COMMUNITY DEVELOPMENT DEPARTMENT REPORT

HEARING DATE: June 16, 2026
Continued from: May 19, 2026

APPLICANT: Hawkins Companies

SUBJECT: H-2025-0007
Syringa Crossing Mixed-Use
Development (aka Hawkins Syringa
Crossing Subdivision) – AZ, CUP, PP

FA3. Mixed Use Community Concept Color Diagram with Markup

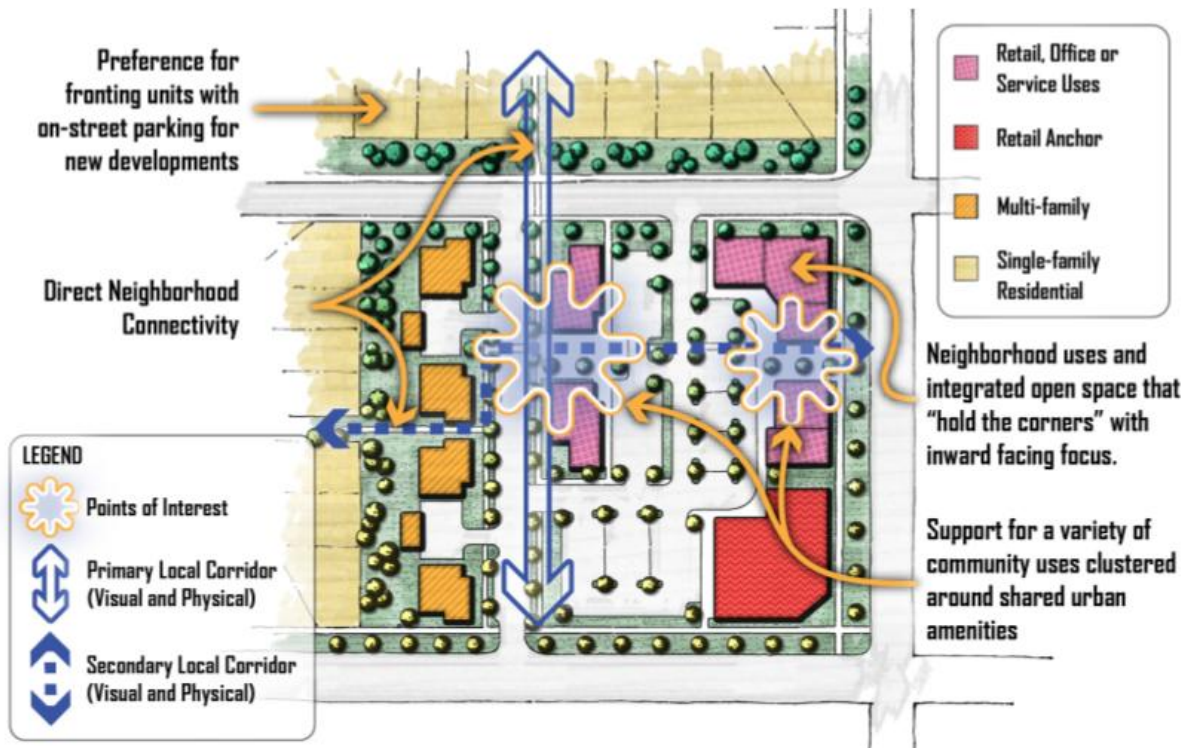
Development review for consistency with the Comprehensive Plan will consider the integration of use and holistic design sub-sections (below) in all mixed-use areas unless otherwise noted. To be successful, the principles outlined must be considered as interrelated features serving the basis of plan design. **Contiguous Mixed Use identified areas that are bisected by an arterial or highway are considered separate and independent areas for use and design integration and will be evaluated independently of each other per the Plan (pp. 3-14 & 3-16).**

E. Conceptual Development Plan for Annexation Area (dated: 1/6/26) - *REVISED*

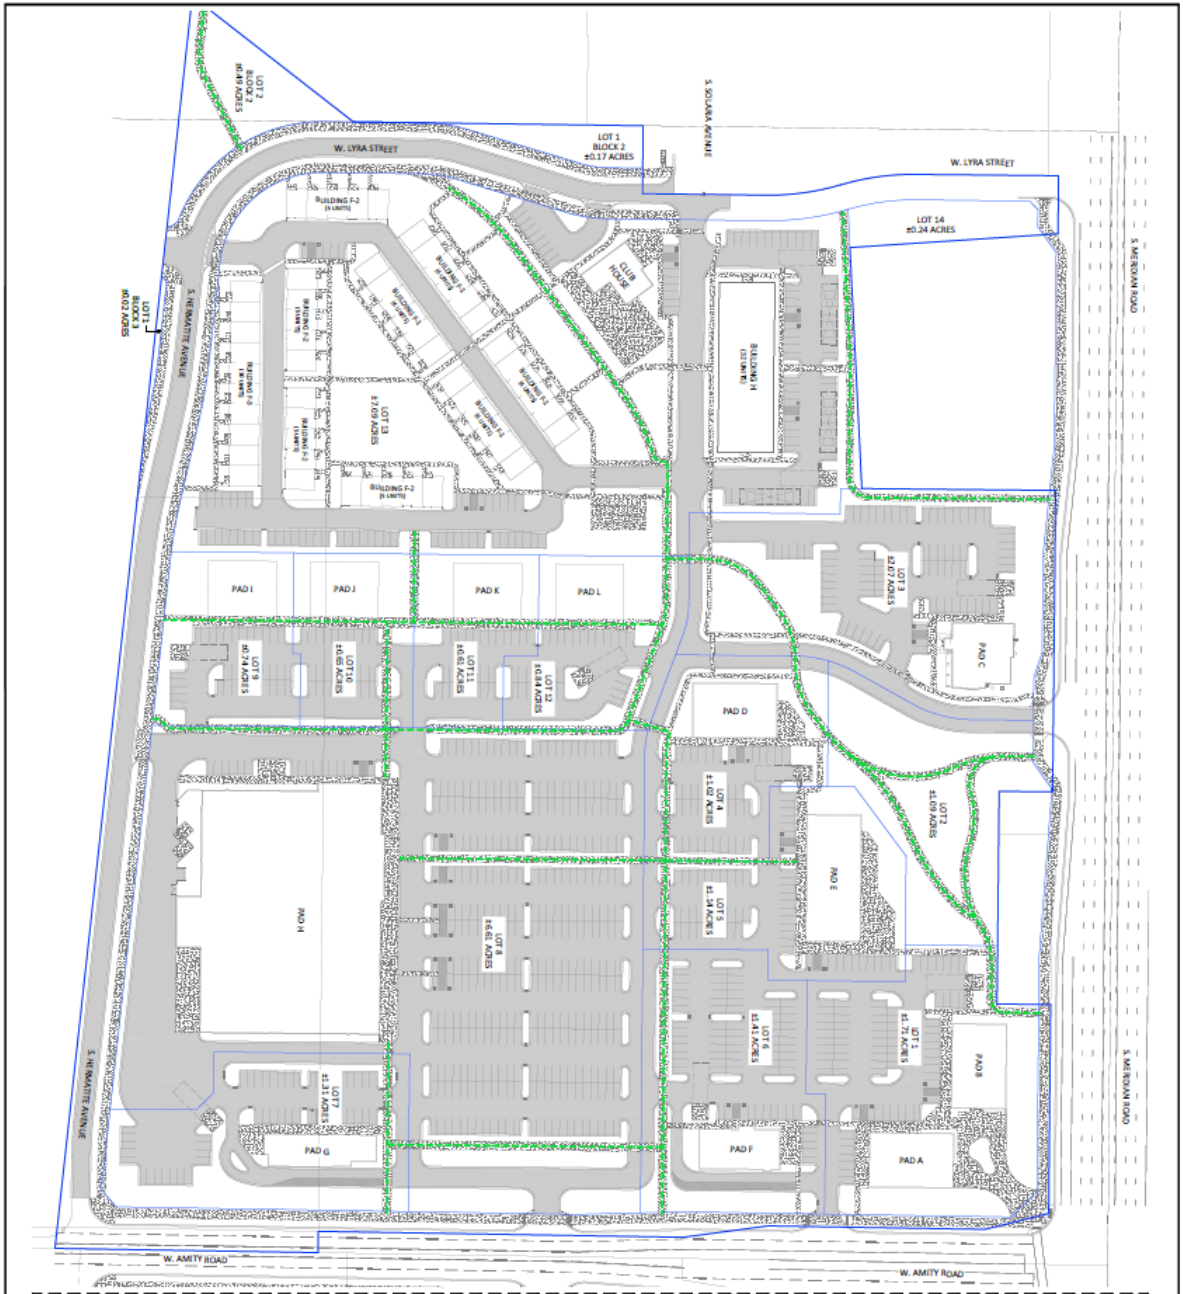
Based on the above-noted general mixed-use and MU-C design principles and analysis, Staff does not find the proposed development plan is consistent with the Comprehensive Plan and therefore, cannot provide a recommendation of approval on the annexation request and consequently the preliminary plat and conditional use permit requests. Additionally, the plans for extension of sewer and water service for this development area do not meet City standards as submitted and are not approved.

- **The conceptual development plan for the SWC of the development should be revised to reflect residential uses comprising between 20% and 50% of the development area with gross densities ranging from 6 to 15 units/acre (of the residential area). Currently, 72% of the 24.45-acre site is residential at a gross density of 18.23 units per acre.**
- **If the NWC property is annexed, the conceptual development plan for that development should be revised to include driveway(s) accesses to the out-parcels (#R4622730010, #S1225449220 & #S1225449910) along S. Meridian Rd./SH-69 that currently take access via S. Meridian Rd./SH-69 for internal access from within the site.**

The access points depicted on the conceptual development plan are not approved and should be evaluated with a future subdivision application.

If City Council determines the proposed annexation *is* in the best interest of the City at this time, Staff recommends the following modifications to the Applicant’s request:

- **Removal of the NWC development from the annexation area until such time as development is proposed to ensure zoning isn’t granted without a more firm plan in place for development that complies with the Comprehensive Plan.**

G. Overall Pedestrian Plan - *REVISED*

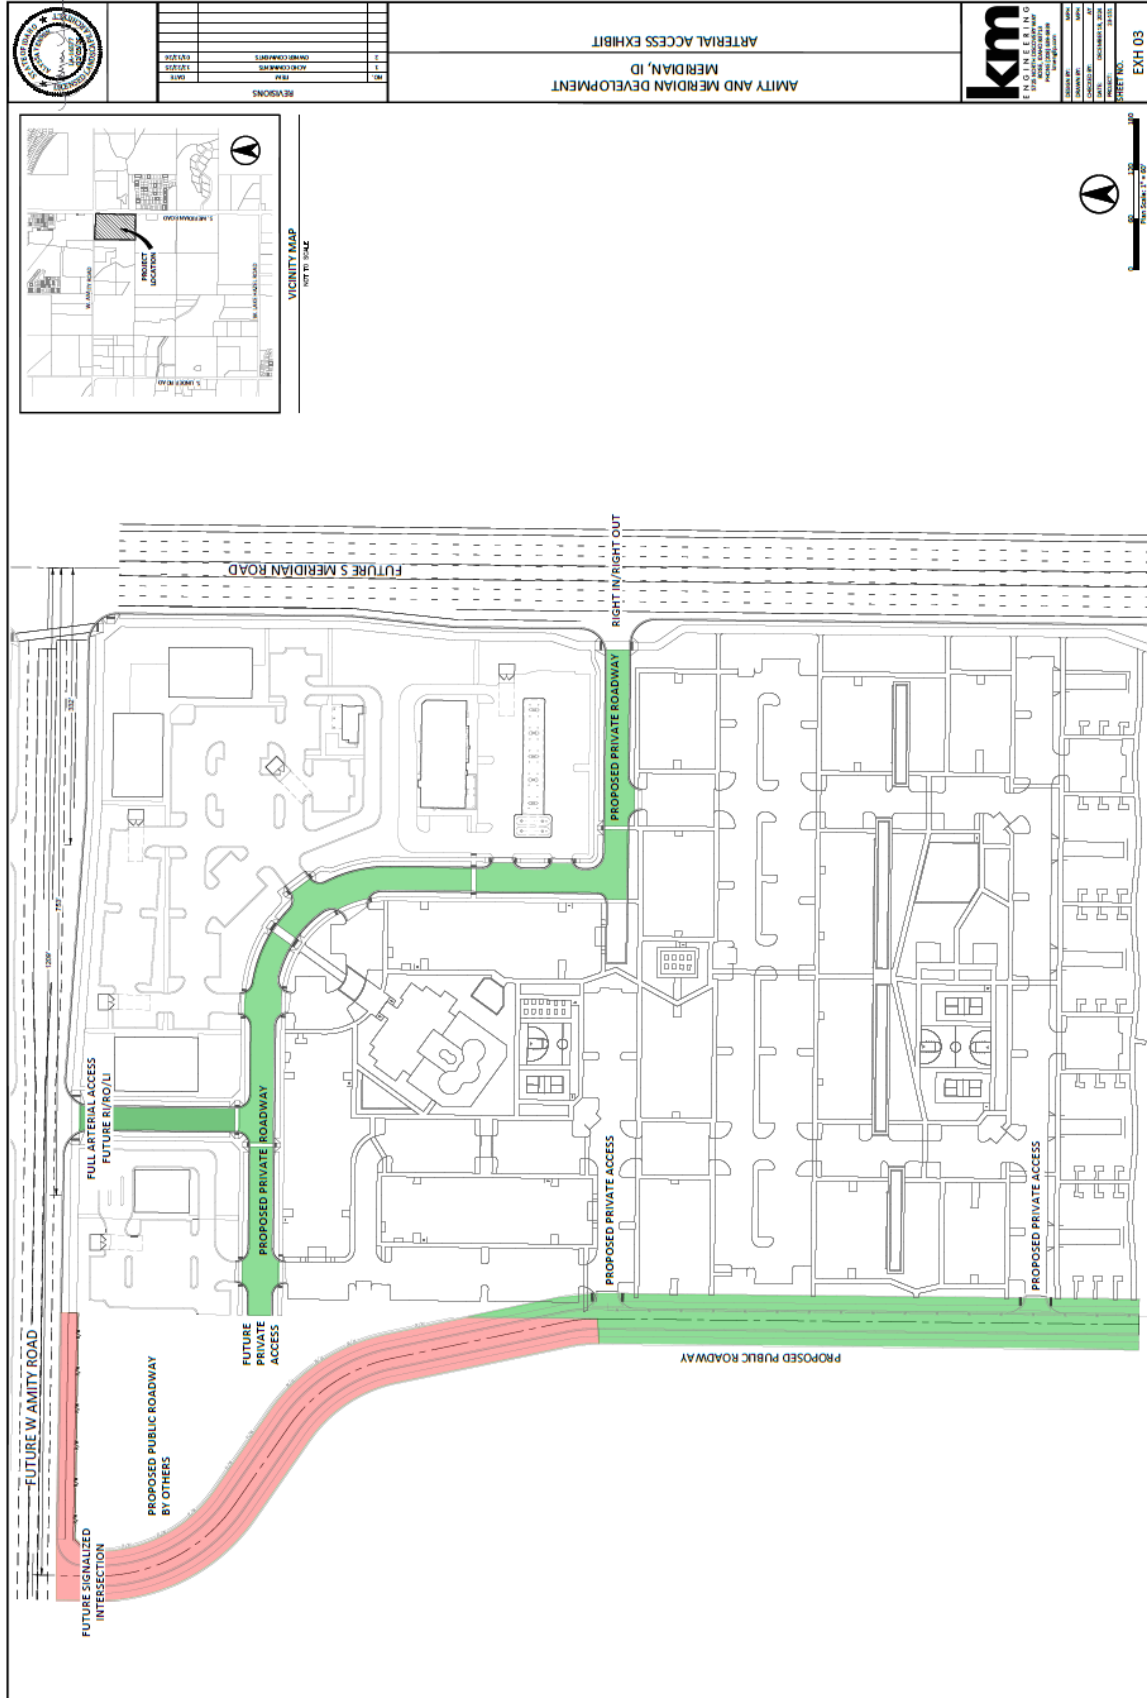
The proposed plat depicts sidewalks as required. ~~The proposed conceptual development plan for the NWC doesn't include 10' wide sidewalks along the collector streets (Lyra/Hermatite) and should.~~ The concept plan was revised to include 10' wide sidewalks along Lyra & Hermatite.

PRELIMINARY PLAT LANDSCAPE PLAN
 MATCH LINE - SEE SHEET PPL3.0

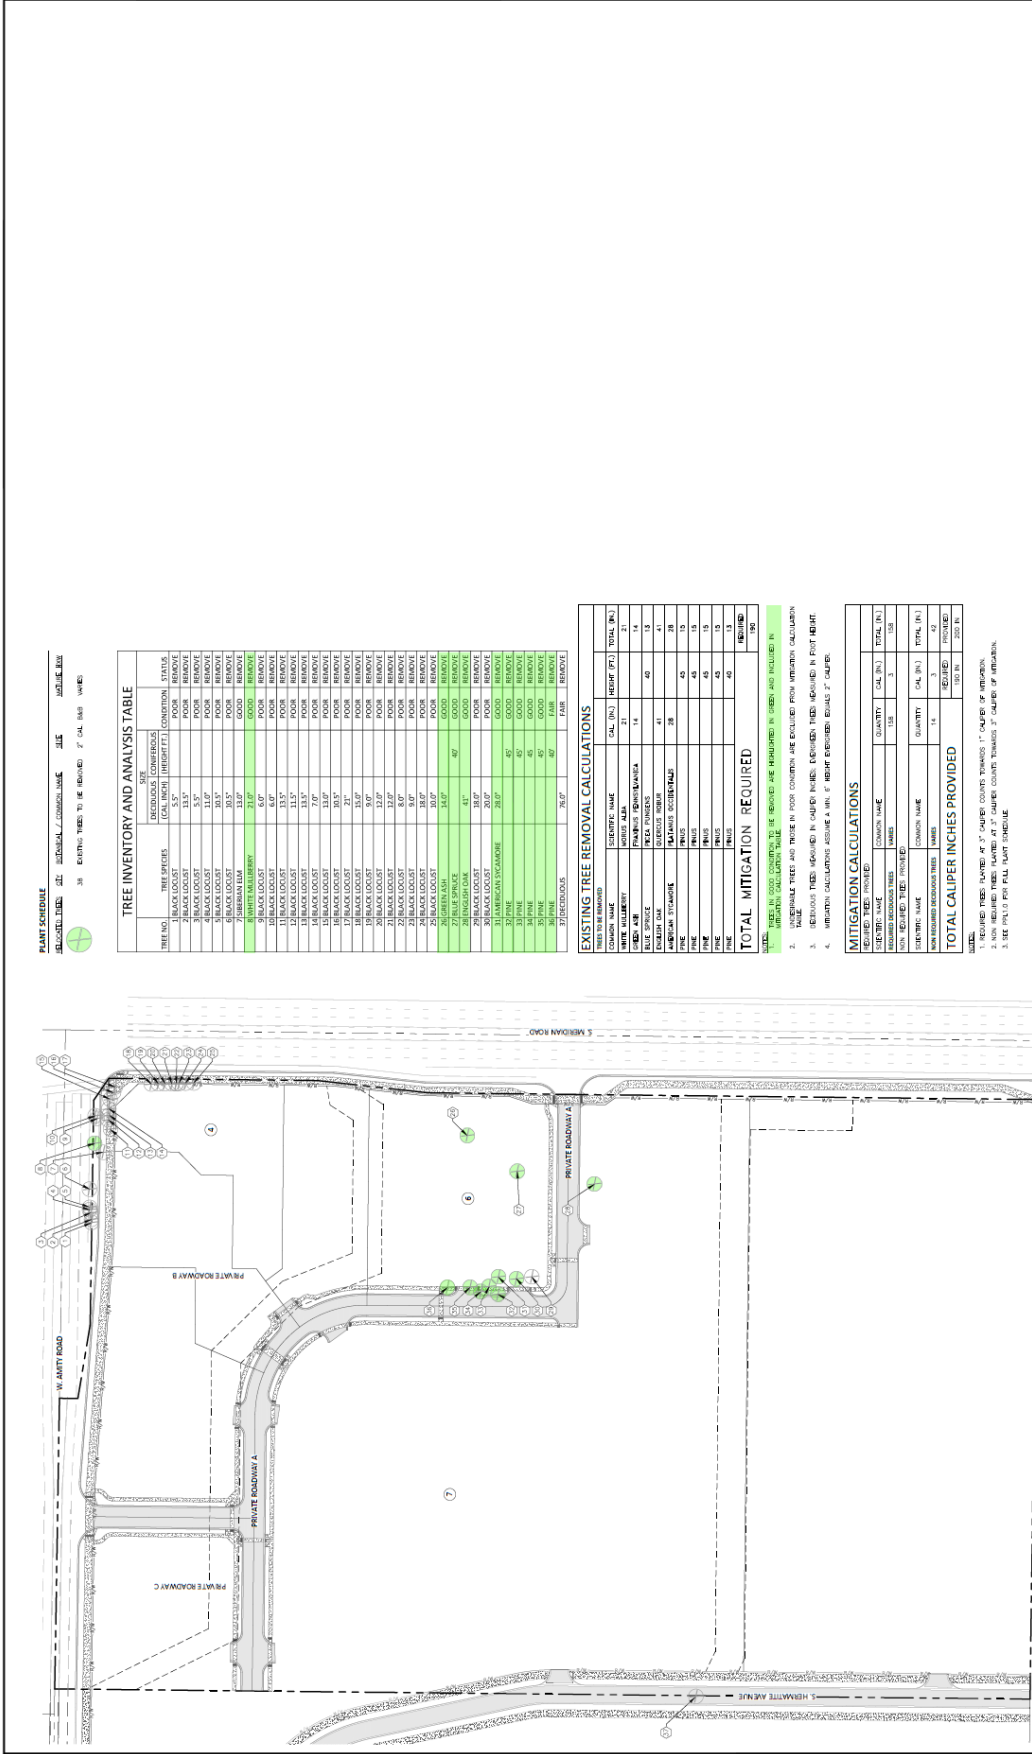
The landscape plan submitted with the CUP application generally complies with the required standards; a detailed review will take place with the CZC application. **The “hatched” areas identified in the Plant Schedule as internal parking lot landscaping should be further defined to demonstrate compliance with the standards in UDC 11-3B-8C.2d and 11-3B-5N, which requires planter islands to be covered with low shrubs, lawn, or other vegetative groundcover at a coverage of at least 70% at maturity.**

Landscaping is required along all pathways per the standards listed in UDC 11-3B-12C. Minimum 5’ wide landscape strips are required on each side of all pathways with landscaping consisting of a mix of trees (one per 100 linear feet), shrubs, lawn, and/or other vegetative groundcover. **The landscape plan should reflect compliance with these standards. Because trees are not allowed within the Northwest gas pipeline easement on the NWC, an alternative compliance application should be submitted to UDC 11-3B-12C.2, which requires one (1) tree per 100 linear feet of pathway.**

If the use is approved, the landscape plans submitted with the final plat and Certificate of Zoning Compliance, as applicable, should be revised to reflect compliance with these standards.

TREE INVENTORY AND MITIGATION PLAN

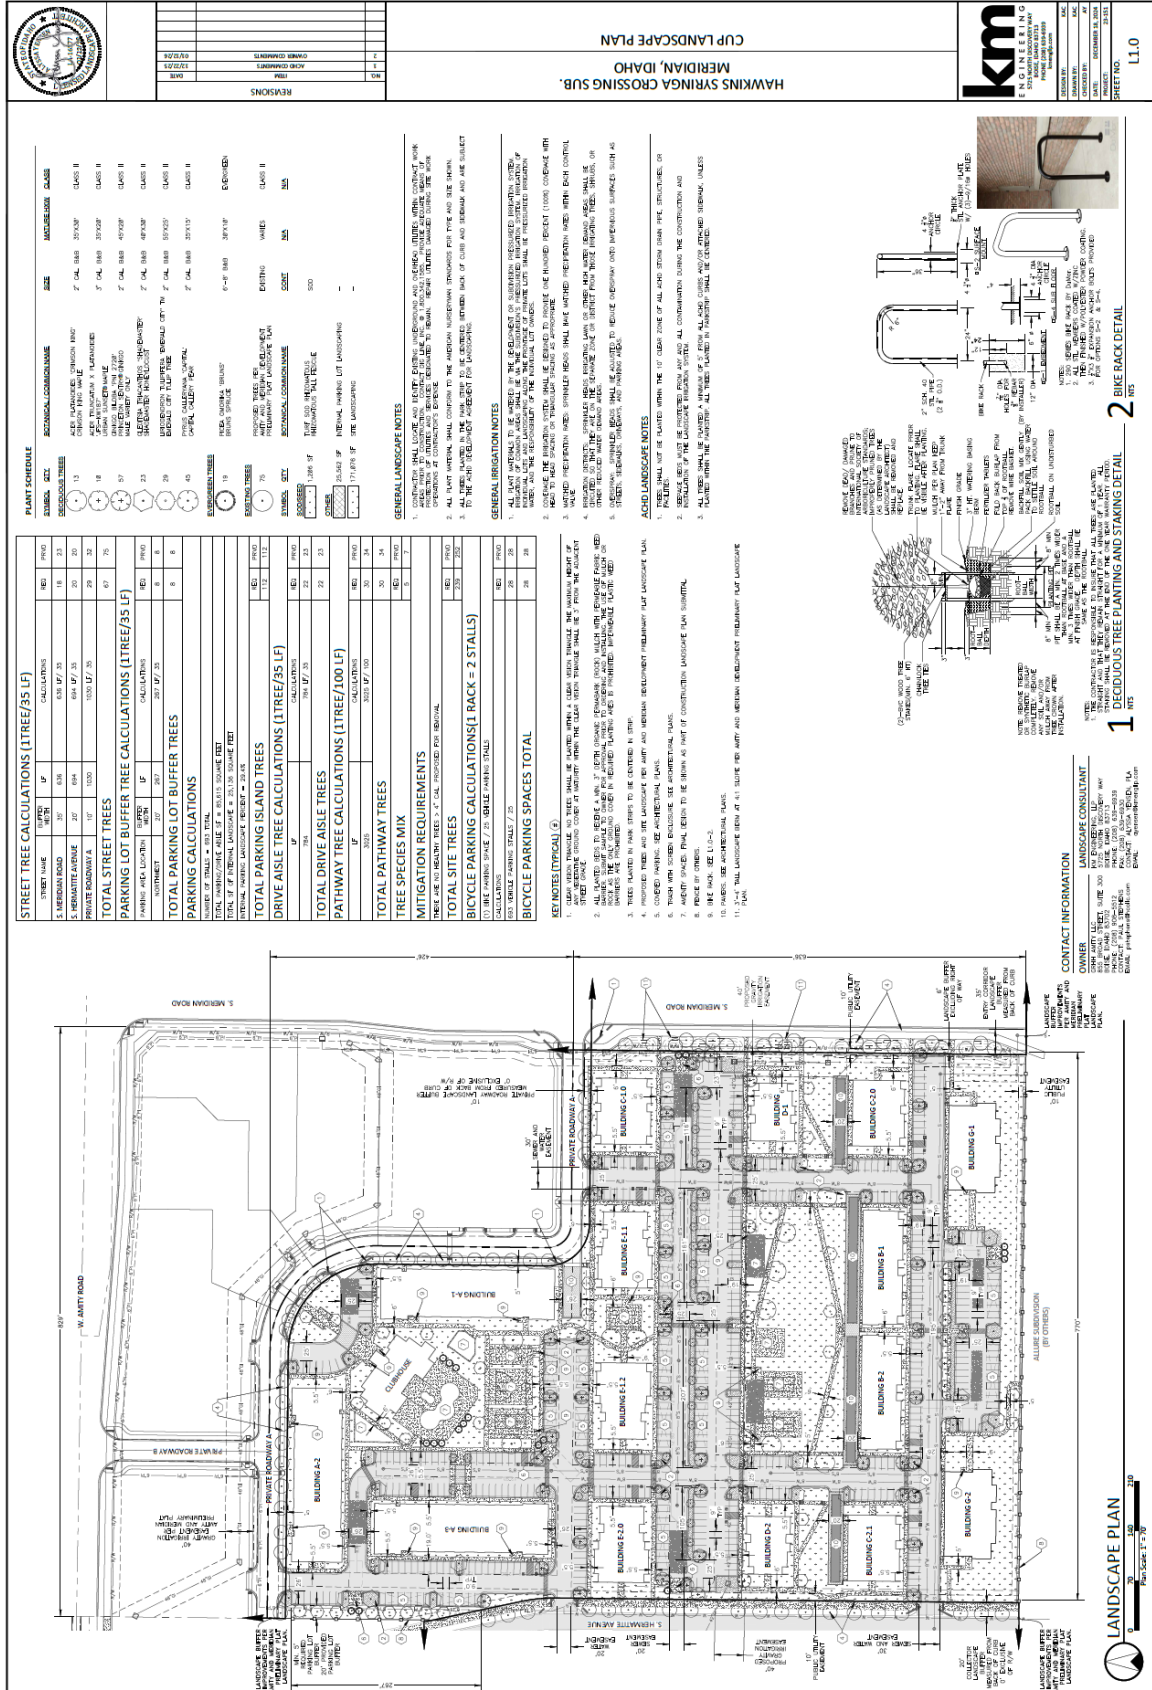
There are several existing trees on the SWC that will be removed with development, some in poor and some in good condition. The Mitigation Calculations shown on the landscape plan submitted with the preliminary plat included below in Section V.J, state 190 caliper inches are required for mitigation with 200 caliper inches provided, in accord with UDC standards.
